Addendum #1

Directorate of Facilities Engineering

18 August 2026

Gardiner Training Site Range Repair, 363 Lewiston Road, West Gardiner, Maine 04345, Project Number 23TR17-604-D, BGS Project Number 3971, Bid Number 21-011

4 TYP COLUMN ENCLOSURE DETAIL
SF502 SCALE: 1-1/2"=1'-0"

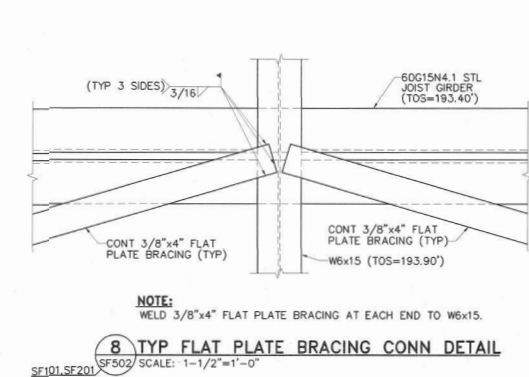
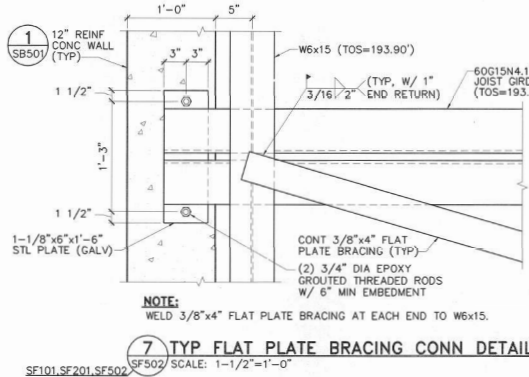
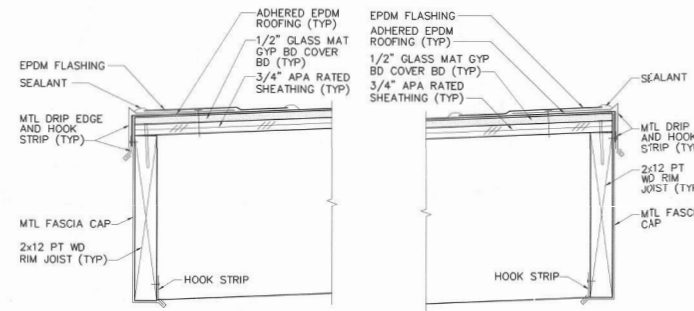
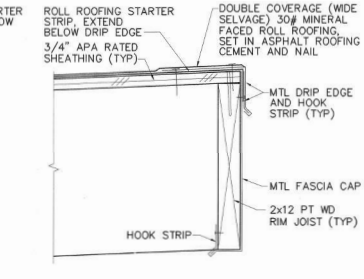
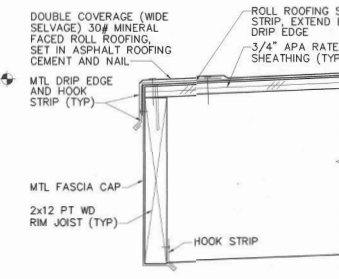
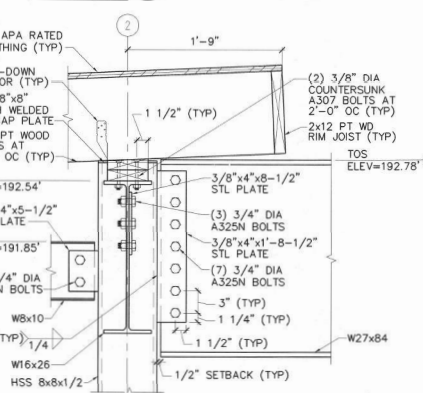
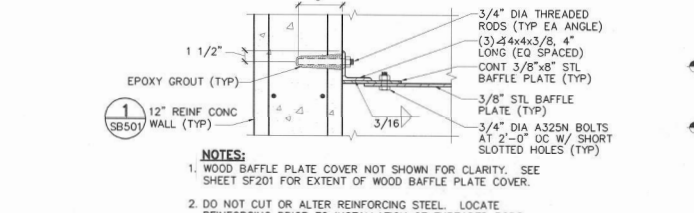
3. **Add** attached sheet SF-502, Structural Details, During the prebid conference it was decided to add the six (6) each columns to the items the plywood would be replaced for. See detail 4 of that sheet for specifics.

4. **Remove** Section 06 16 00, Page 1, Sheathing and **Replace** with attached Section 06 16 00, Page 1, Sheathing. Change is Part 2, Section A, Plywood. Also, on the drawings **Replace 7/16" with 1/2"** for marine plywood thickness.
